## **STAFF REPORT AND RECOMMENDATION TO THE DESIGN COMMISSION**

**CASE FILE:** LU 19-204560 DZM AD  
 PC # 19-157911  
*Dairy Apartments*

The following Staff Report recommends *denial* of the proposed Design Review and denial of multiple Modification requests.

**Proposal:**  
 The applicant is seeking Design Review approval for a 7-story, 271-unit residential structure on the full block site occupied by the former Sunshine Dairy building. A single full-block

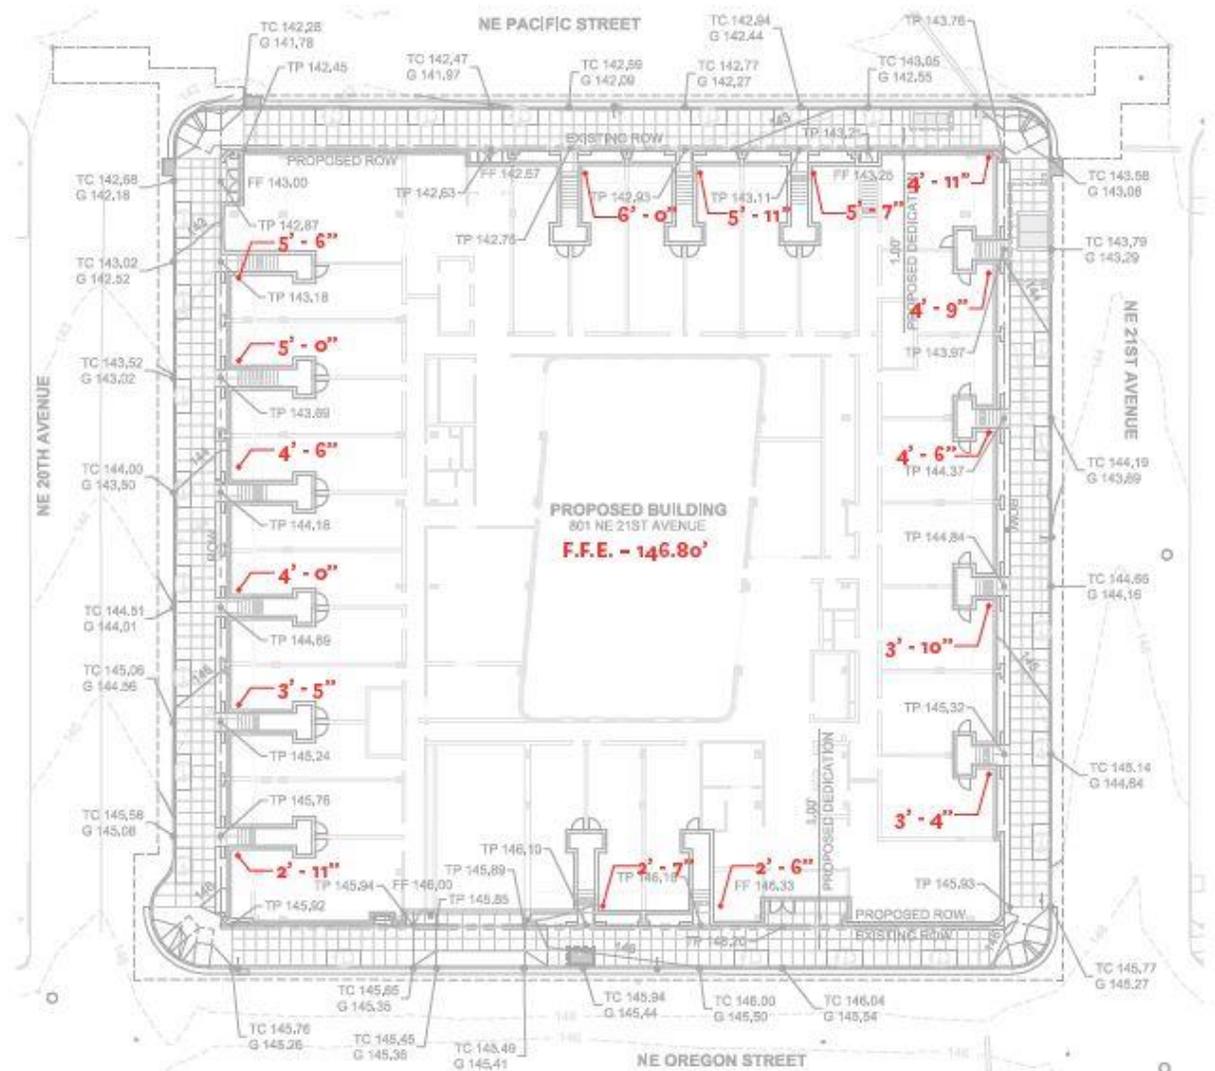
At the Design Advice Request, the Commission stated that porch heights should be 30-36 inches above the sidewalks, and not more than that. As shown in exhibit C-27 (image below), only three of the sixteen ground floor units are within this range. Nine of the porches are 54-72" above the sidewalk. With the addition of a painted railing at the front of each porch, and the eight-foot entry gates between porches, the perceived wall height for the pedestrians is greater than just the porch elevation.

Staff suggests that a combination of the following strategies may be utilized to enhance the public realm and lower the maximum porch height to 36” without reducing quantity of units:

- *The floor plate may be lowered on the northern half of the building to match the floor plate of the commercial tenant space at the northwest corner. The units on the north frontage (NE Pacific) are currently six feet above the sidewalk. Lowering*

*these units may create opportunity for work-live spaces with mezzanines at the rear.*

- *Lowering the floor plate across the building would provide eight-foot deep porches on the south frontage. While not elevated above the sidewalk, Staff feels that this depth, on the least active pedestrian frontage could facilitate high-quality, sunny outdoor spaces for the residents with deep landscape buffers.*
- *Reducing the depth of the front porch on the tallest porches may provide sufficient space for a second tier of raised planter.*

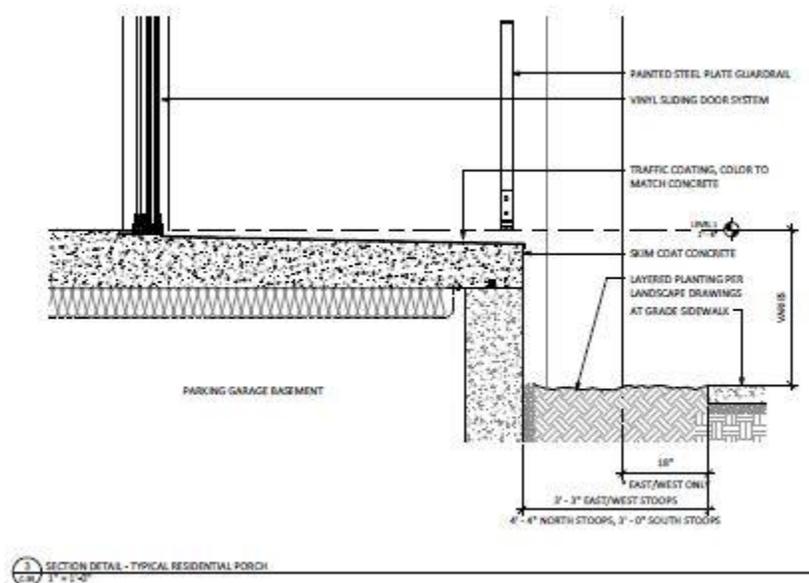
In consideration of the qualities of each of these street frontages, the publicly accessible commercial spaces provided on site, and the goal of maintaining tenant privacy, Staff and the applicant agree that benches may not be an appropriate element to locate outside of private units. However, to meet this guideline without providing physical resting spaces, it reinforces the need for private residential porches to be at a height where interaction with neighbors passing by is convenient. At the porch heights proposed, the architecture discourages pedestrians from looking up into private porches, and it is physically uncomfortable to have a prolonged conversation.
